Fort Lauderdale Police Headquarters Project Update

CITY OF FORT LAUDERDALE
February 18, 2025 Conference Meeting

WJE – Phase 1 Summary of Findings

WJE – Phased Approach – Roof Beams (Cantilever)

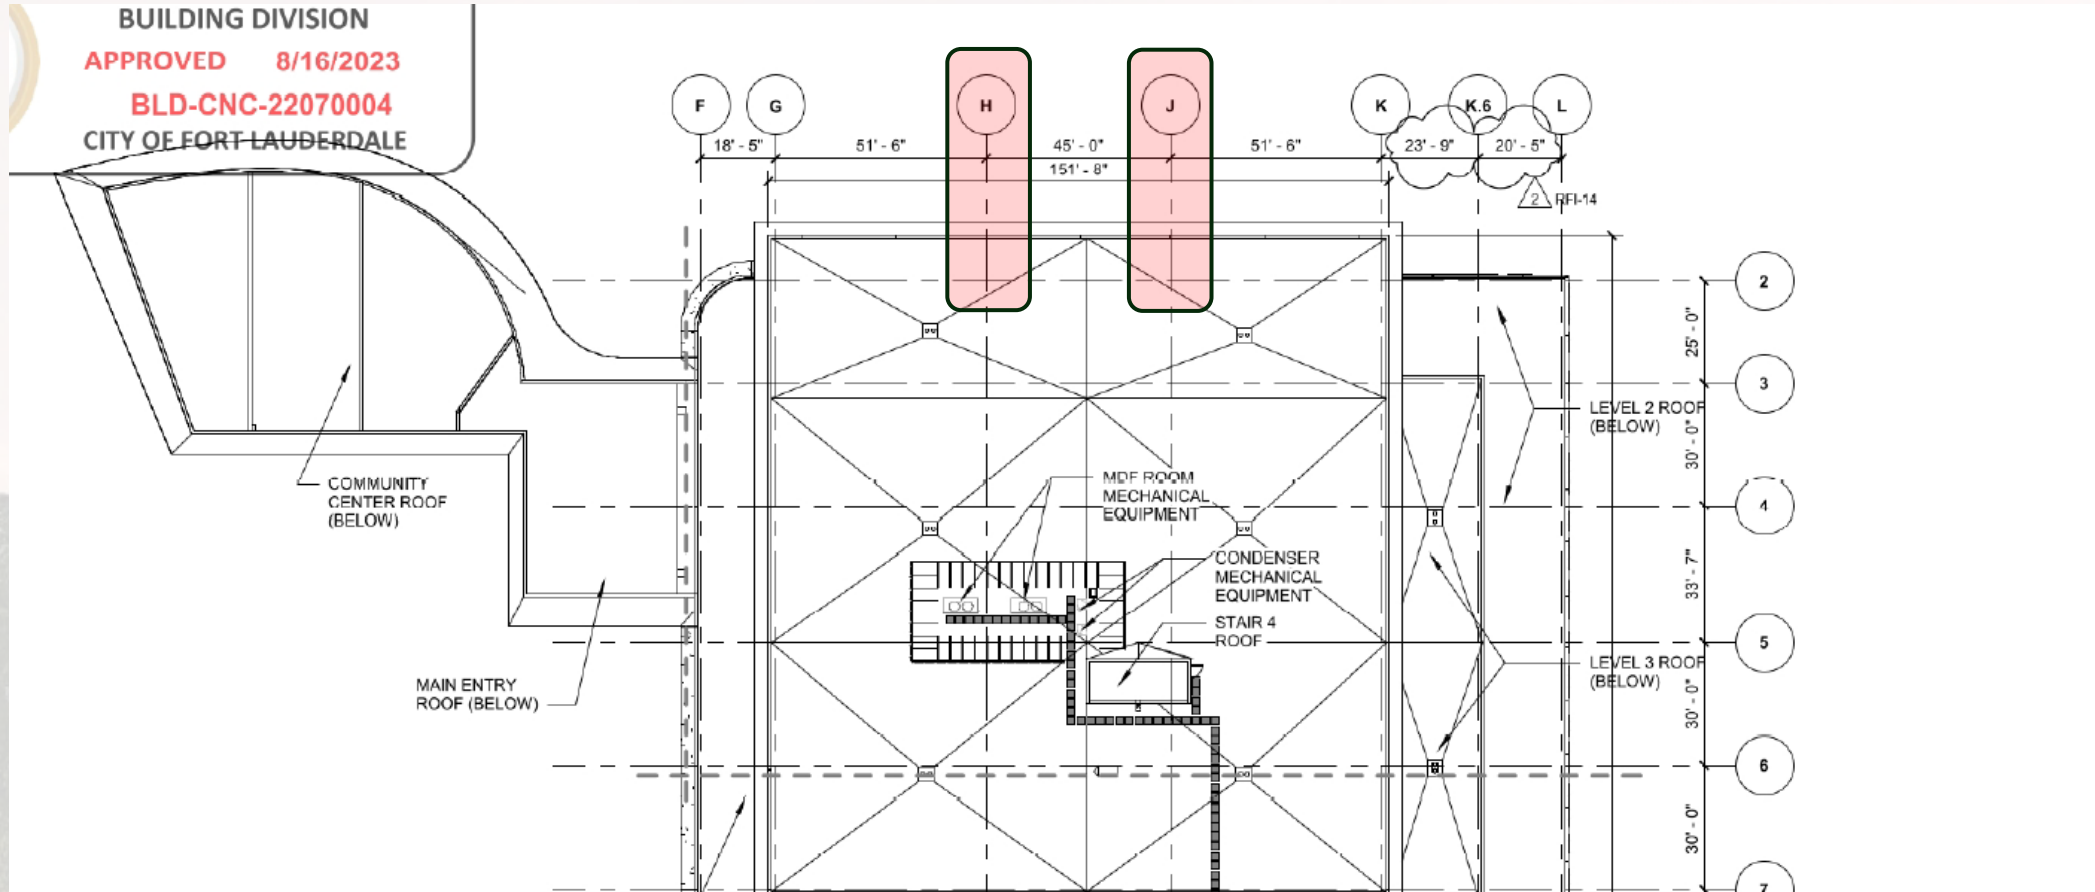
- Roof Beams
 - WJE Concurs that the Roof Cantilever Beams Were Not Fully Code Compliant
 - WJE Finds that Previous Rectification Efforts Did Not Bring the Beams Fully into Code Compliance
 - WJE Finds that Cantilever Beams at Gridlines H & J Are Not Fully Code Compliant
 - WJE Finds that the Spandrel Beams North of Gridline 2 are Fully Code Compliant
- Third Floor Beams
 - WJE Finds that 3rd Floor Cantilever Beams & Spandrel Beams North of Gridline 2 are Fully Code Compliant

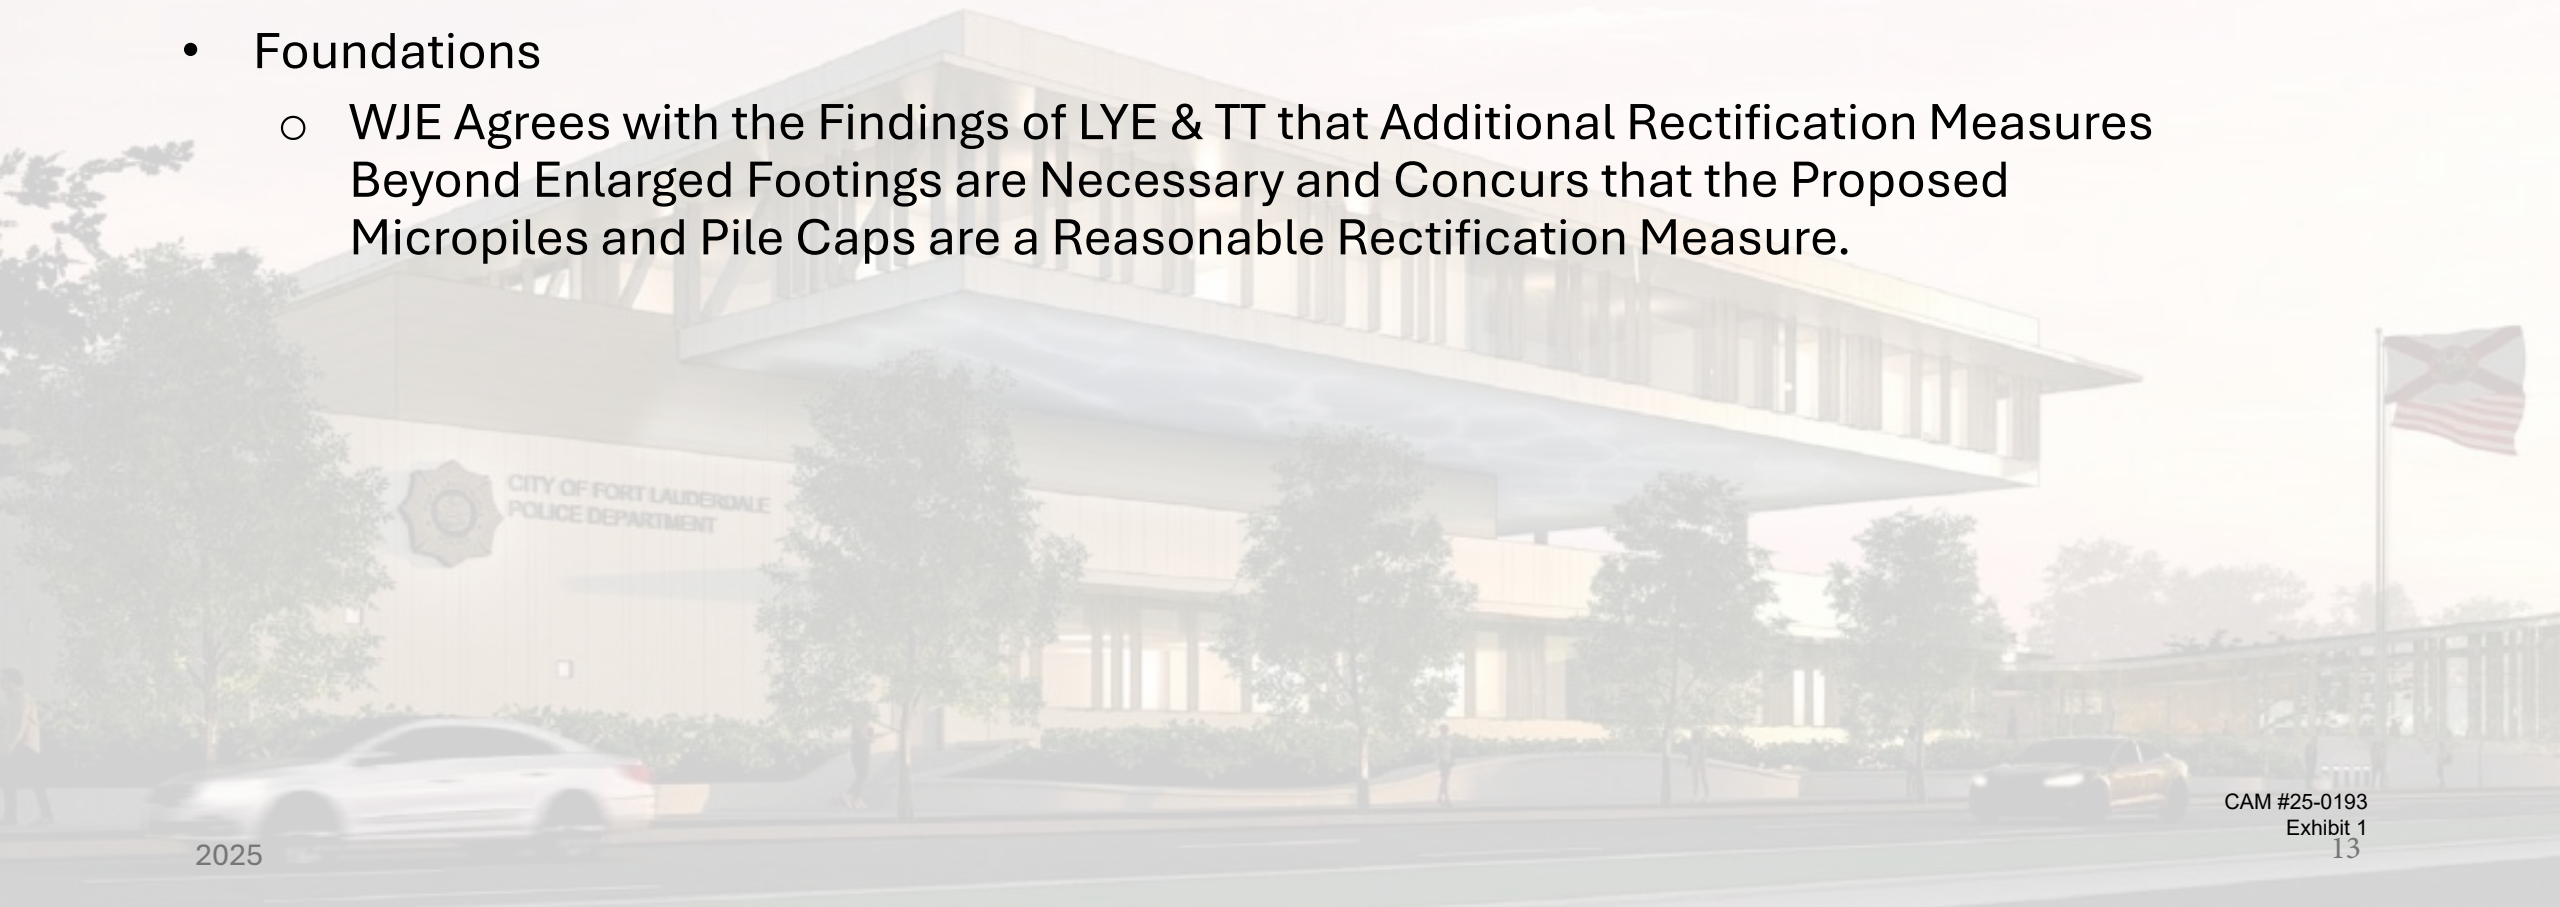
- First Story Columns
 - WJE Agrees with the Findings of LYE & TT that Rectification Measures are Necessary for Code-Compliant Strength.
 - WJE Made Additional Minor Recommendations for Columns on the 1st Floor
- Foundations
 - WJE Agrees with the Findings of LYE & TT that Additional Rectification Measures Beyond Enlarged Footings are Necessary and Concurs that the Proposed Micropiles and Pile Caps are a Reasonable Rectification Measure.
